Service Bulletin

Bulletin No.: 24-NA-133

Subject: Wheel Drive Shaft Retention Snap Ring Design Change

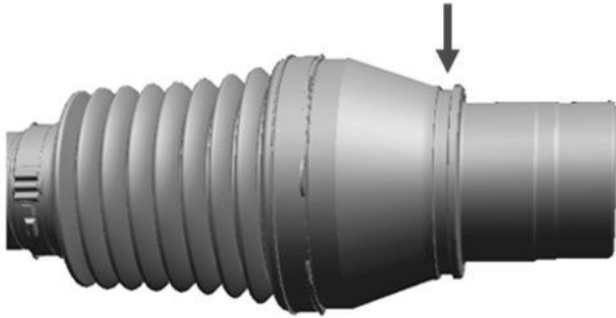
The round ring and 3-Point rings are not interchangeable with either the wheel drive shaft and/or the drive unit. Do Not mix snap rings between wheel drive shafts and drive units.

The above vehicles starting using a newly designed 3-point snap ring that retains the wheel drive shaft to the drive unit output shaft.

The design change occurred to achieve greater retention forces between the wheel drive shaft and the drive unit output stub shaft.

On vehicles equipped with ball-spline wheel drive shaft, the presence of a service groove (as shown below) on the inboard housing means the drive unit is equipped with the 2nd design 3-Point snap ring.
